U.S. Department
of Transportation
**Federal Highway
Administration**

In Reply Refer To:
HSSD/WZ-140A

Attachment 1 – Description of Modifications
Impact Recovery Systems, Inc.
WZ-140 Flexible Traffic Control Product

Figure 1 - OmniPed Solar Pedestrian Vertical Panel

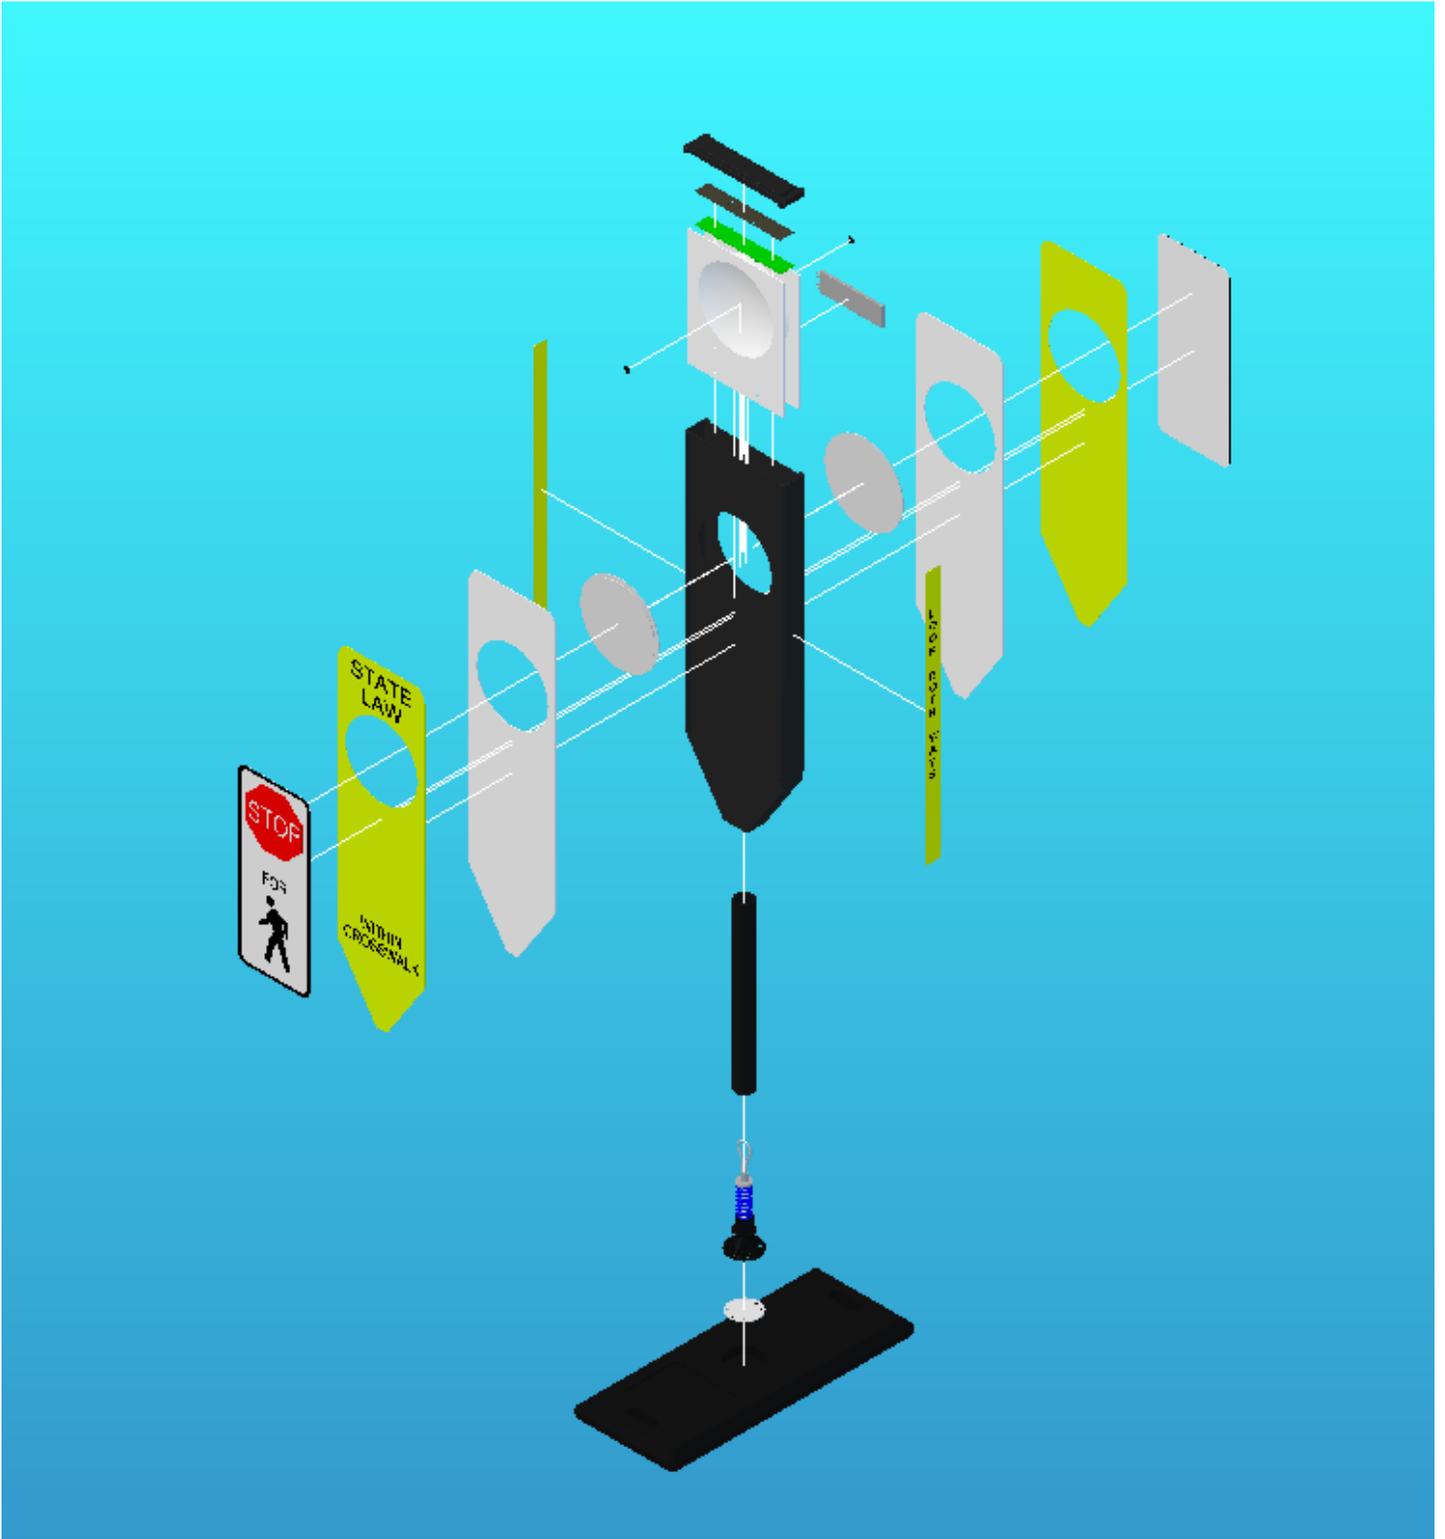
The modified system retains the One Base portable stand along with the spring and tube systems. However, the new sign now consists of a blow molded HDPE form of similar thickness used as sign substrate. The light is no longer an externally mounted Empco, but an internally mounted (for internal illumination through translucent reflective sheeting) solar arrangement consisting of a PCB and solar cells located in the top, a lithium polymer battery internally mounted, and two small circuit board mounted LEDs.

The new sign dimensions are 14” x 48” x 3”. Total weight including the two lights and portable base remains at 22kg (48 pounds) as the weight savings of lighter batteries are offset by a heavier sign substrate.

Whereas the new sign houses lighting internally mounted and is of single piece design, we believe the overall arrangement will act in a manner equal or better to the previous system. No externally mounted lights are available to break free a fly about. Also, the single piece sign substrate will have better integrity upon being struck, with fewer protrusions to hang up on various vehicle exposures.
